Notice of Allowability

10/702,506

TSIRONIS, CHRISTOS

EXAMINER'S AMENDMENT

FIG. 8 Partly Prior Art - Cross section

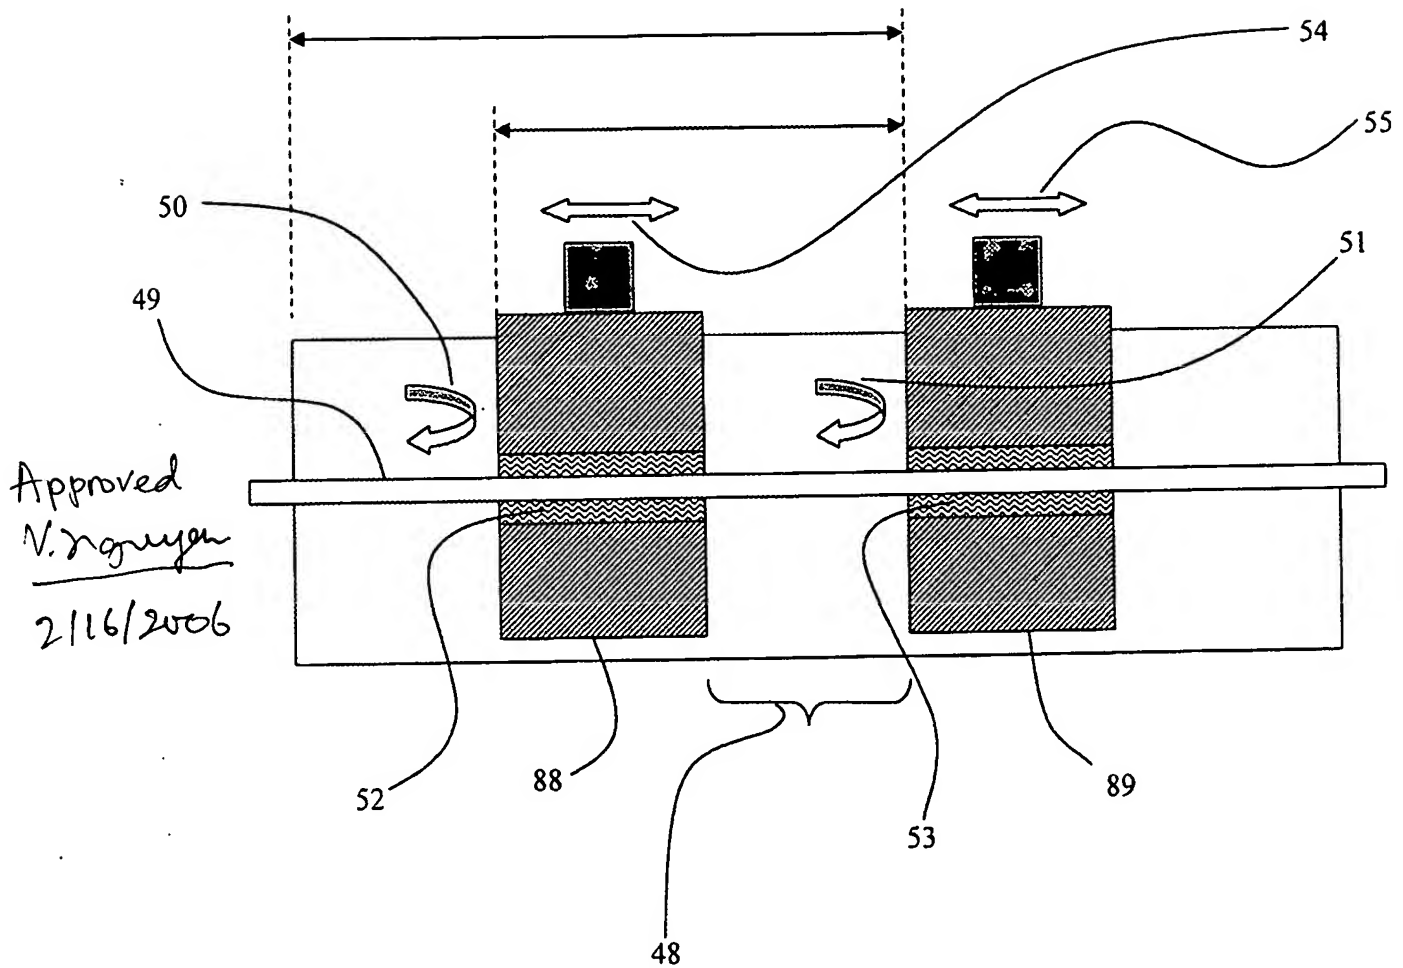
NOT PART OF THE DRAWING
 (FOR ARGUMENT ONLY)

Figure ii: Combination "Metal-Dielectric" Probe (this invention)

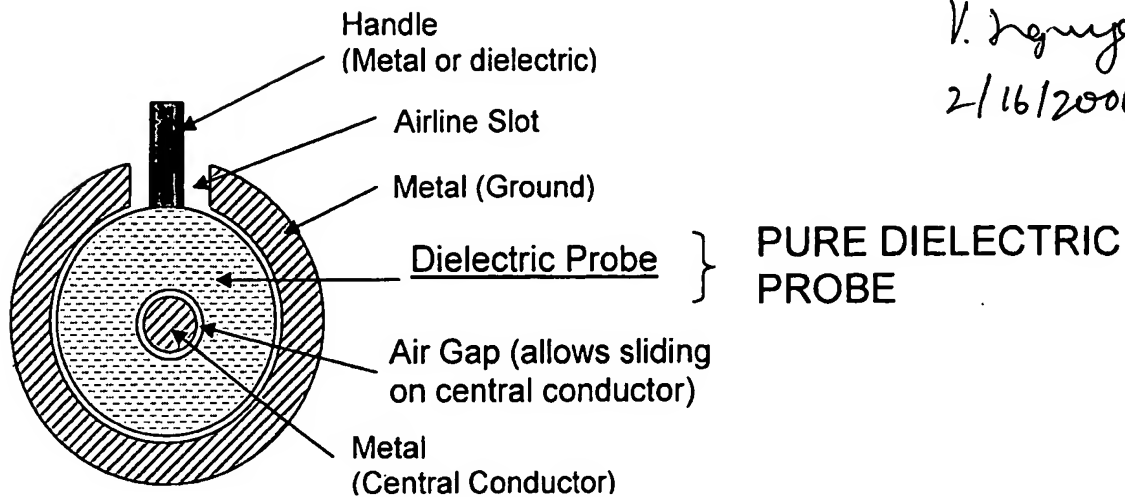
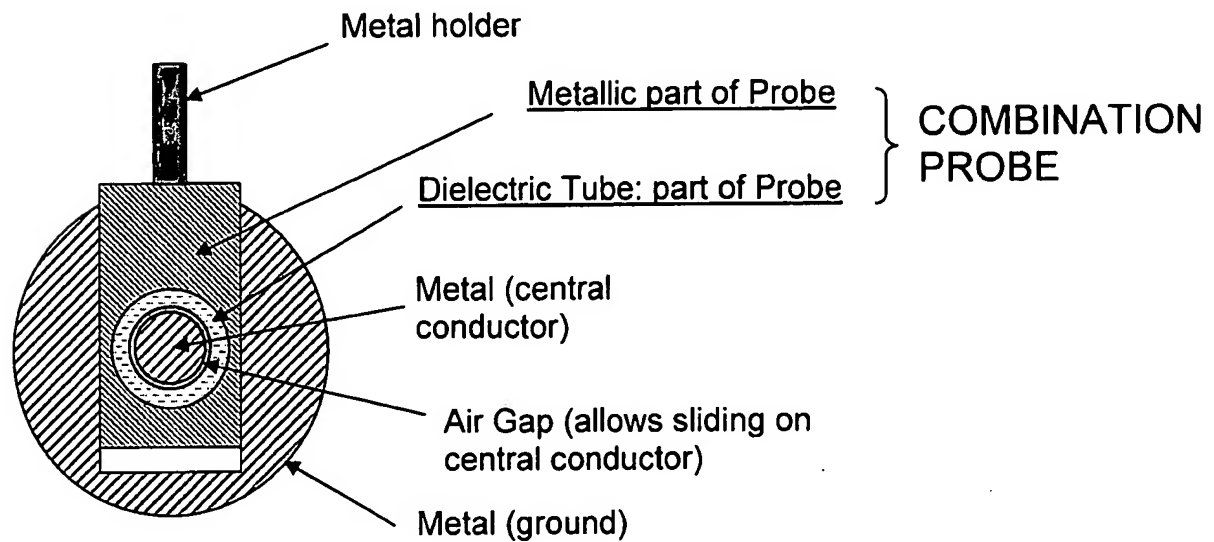
NOT PART OF THE DRAWING
(FOR ARGUMENT ONLY)

Figure iv: Tsironis' (US patent 6,297,649) Prior Art: Vertical Resonant Probe

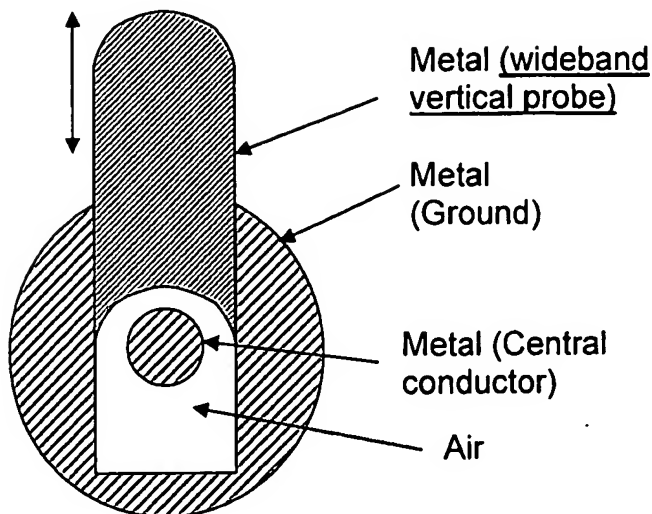
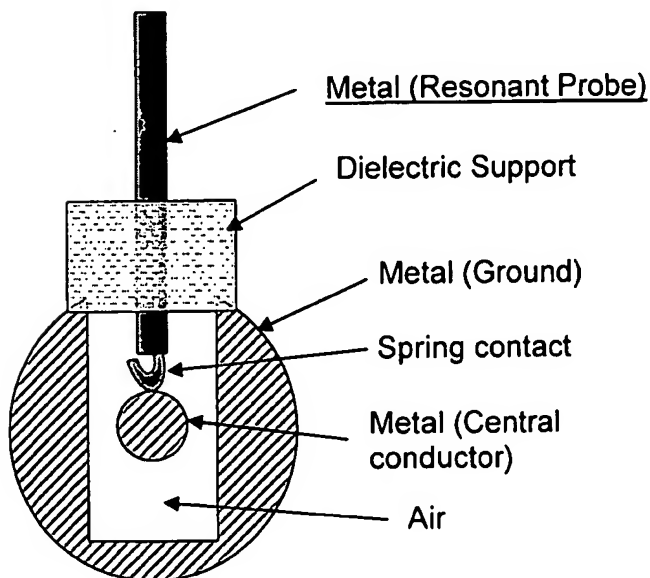
NOT PART OF THE DRAWING
(FOR ARGUMENT ONLY)
